SEWAGE DISPOSAL SYSTEM

A 07125 A 514935-A

MARYLAND STATE DEPARTMENT OF HEALTH

SUBDIVISION Holiday Hills 10825 Hunting Lane ROAD LOT 55, sec. 5

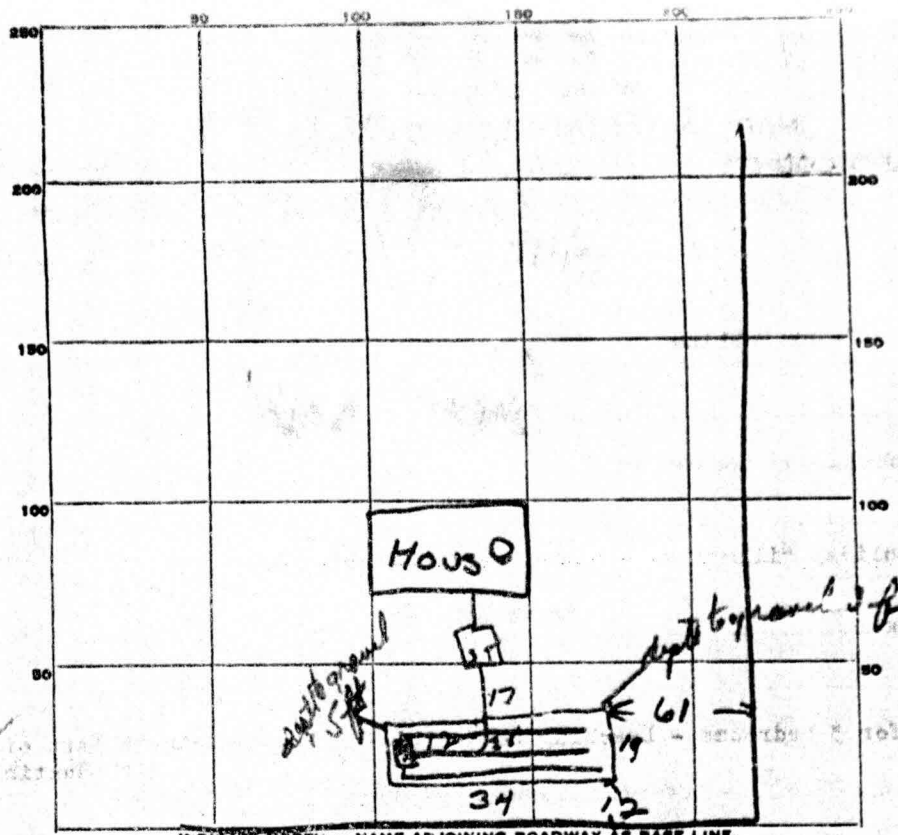
REMARKS 12/5/63 - not enough gravel under distributor pipe only 1 1/2 ft - should be 3 ft - not enough gravel over pipe - only 2" - should be 8"
Bed to deep at pt closest to right side line.
OK to approve because bed is 2500 gal length required - 595 gal in 76 sq ft larger than required.

DATE SYSTEM APPROVED 12/5/63 INSPECTOR W. Monaghan
